CABINET MEMBER FOR ENVIRONMENT – 2 MARCH 2017

PROPOSED RAISED JUNCTION TABLE – BROAD STREET JUNCTION WITH PARKS ROAD, HOLYWELL STREET AND CATTE STREET - OXFORD

Report by Director for Infrastructure Delivery

Annex 1

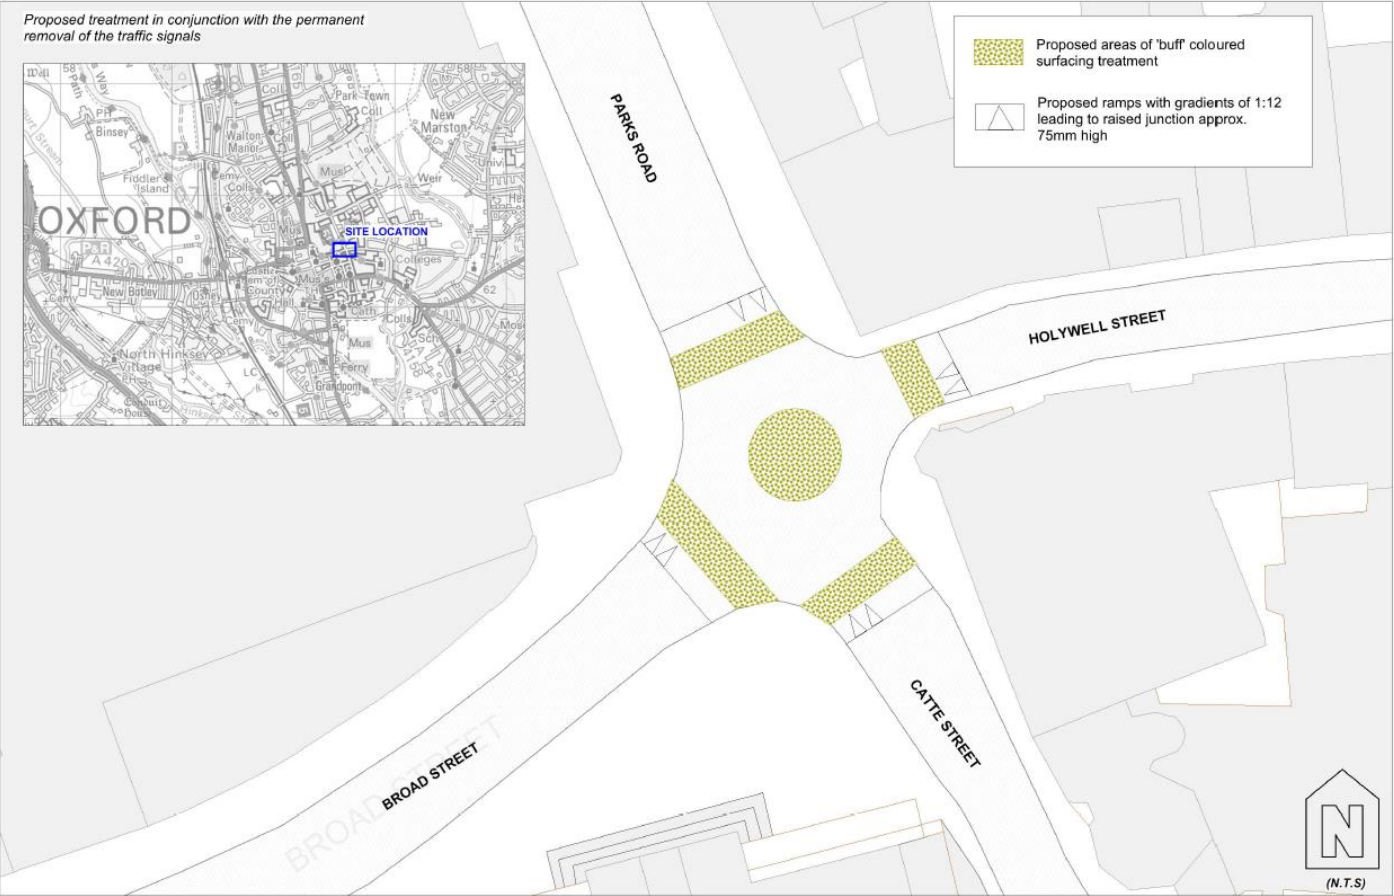
Cycling UK	Object – while welcoming the removal of the signals, considers that the proposed height of the table (75mm) is insufficient to achieve the adequate levels of speed control, although also considers that the 1:12 gradient ramps are too steep for cyclists, suggesting a gentler gradient or different profile. Also objects to the detail of the proposed applied surfacing, suggesting possible alternative arrangements, and considers the road hump markings to be not in character with the area. Also noted that the consultation plan did not provide details of kerb upstands (including any amendments to the double height kerb on the north west corner of the junction) and the paving.
Oxford Bus Company	Neither - Whilst this is not on the primary route network for OBC it is on a diversionary route used by our buses (mainly when the St Giles Fair is in residence) or in other situations so the ability to for buses to use this is needed; supports the proposals based on the 75mm above existing carriageway height and a gradient of 1:12. We would be able to fully support the proposals if they also indicated a length of 1500mm and width of 600mm to ensure that a bus can use it safely and comfortably for passengers and the driver. Could OCC please confirm these elements of the scheme?

<p>safer behaviour on the part of most road users, though some vehicles enter the junction too fast, especially from Holywell Street taking account of the limited sight lines from this approach. The raised table With 1:12 gradient ramps is likely to be an acceptable solution, though its effectiveness will depend greatly on the visibility of the differential buff colouring, and the exact positioning of the proposed central circle of buff surfacing (a query was also raised on whether an 'egg' shaped area of such surfacing might be more effective). However also considers some additional measures to reduce speeds are advisable, suggesting for example a visual island (possibly over-runnable) on the Parks Road approach in particular to assist the many pedestrians crossing here.</p> <p>Also raised a query on the kerb upstands (taking account of the proposed 75mm height of the table) and expressed view that the kerb must be retained on the South-west corner, to reduce the temptation for cyclists to cut across the plaza in front of the Clarendon Building, and that the double kerb on the North west corner should be removed due to the hazard it presents to pedestrians.</p>

Resident	<p>Neither – expressed concern over dangers due to cyclists travelling through the junction at excessive speed, and suggested some form of control / priority is needed, but no need to raise the surface of the whole junction. Ideally the traffic signals should be reinstated, with a pedestrian phase. An alternative would be a mini-roundabout, with raised informal crossings on the two Parks Road and Broad Street where most pedestrians cross.</p>
Resident	<p>Object – supports the removal of the traffic lights, but considers the treatment is too intrusive in an area of exceptional historic and architectural significance and should be made minimalist with as little street furniture and roadway features as possible, and suggests just the mini-roundabout with textured road surface.</p>
Resident	<p>Object – supports the removal of traffic lights and all road signs but considers that the raised junction table is unnecessary and unsightly and should be omitted, & that the buff-coloured road surface should be applied on all the junction area.</p>

Resident	<p>Neither - Much preferred the junction when the traffic signals, due to motor vehicles not exercising due care. However, not opposed to a mini-roundabout type layout but concerned that the raised table and applied surfacing will not be maintained and present a hazard to cyclists, and suggests the provision of a conventional mini roundabout.</p>
Resident	<p>Neither – in favour of the removal of the signals, but considers that adjustments are also required to the Holywell Street approach to provide more visibility, which would require significant amendments to the existing kerb lines. Also expressed view that additional measures were needed to assist pedestrians.</p>
Resident	<p>Object – would like the traffic signals re-instated – the treatment is unnecessary and is not in keeping with the surrounding buildings, and does not assist the many pedestrians crossing here.</p>
	<p>Neither – while supporting the principle of a roundabout in place of the signals, expressed concern that the table</p>

15. The queries on the detailed design issues raised by the University, Cyclox and Cycling UK were discussed at a site meeting on 17 February attended by their representatives and officers, which clarified the points raised, and identified a number of adjustments to the detailing of the footway works required to accommodate the raised junction table.

20. The provision of a conventional mini roundabout has been considered, but the signing and road markings required are not judged to be in keeping with the character of the area, and would also likely not in practice operate with any greater levels of safety than the proposed treatment, taking account of the monitoring of the similar treatment used at Frideswide Square.

21. The request for one or more zebra crossings is also noted, and while it is accepted that such crossings would provide positive priority for pedestrians, siting such crossings on the current desire lines for pedestrians would require them to be very close to the crossroads, which in turn could impair the operation of the junction. It should be noted that, when operating, the traffic signals did not provide any pedestrian lights.

22. The scope to significantly adjust the kerblines of the junction as suggested in two of the responses is not considered to be within the scope of this interim scheme, but could be investigated as part of the planned major environmental improvement.
